AMENDMENTS TO THE DRAWINGS

REMARKS/ARGUMENTS

Fig 5

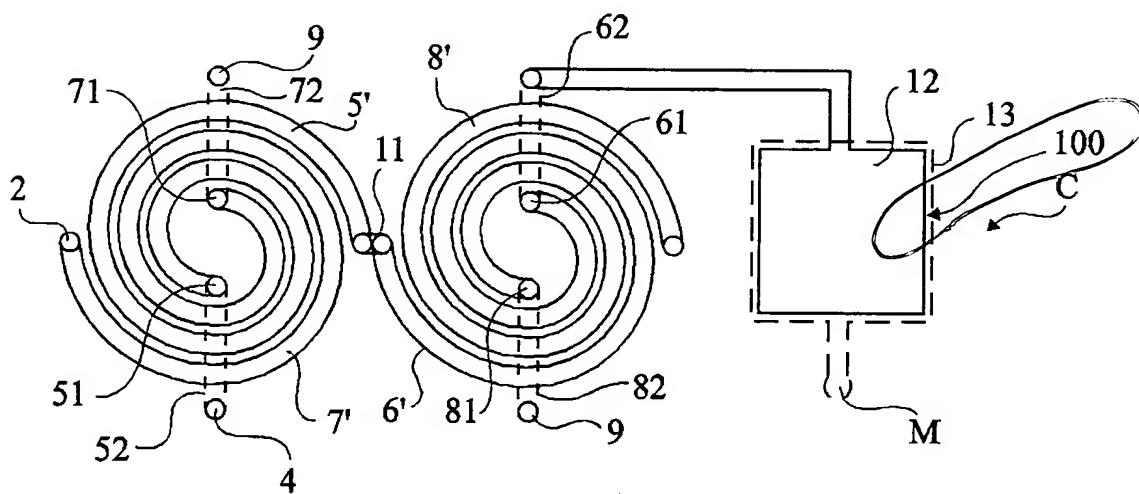
Amended Fig. 5 shows conductive layers 12 and 13 separated by a dielectric 100. Fig. 5 does not enter any new matter as this feature can be drawn directly from paragraphs 18 and 37 in addition to paragraphs 38 and 39 of the present application.

Fig 6

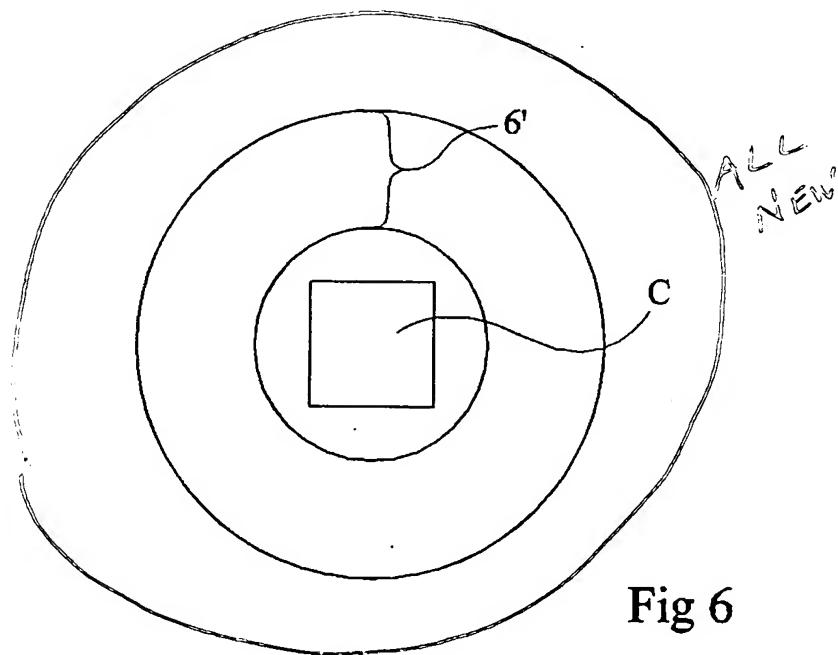
New Fig. 6 shows the realization of the capacitor C located in the center of the spirals of the first sections 6'. Fig. 6 does not enter any new matter as it can be drawn directly from paragraphs 17 and 40 of the present application.

Regarding claim 4, new Fig. 6 has been added to overcome this rejection.
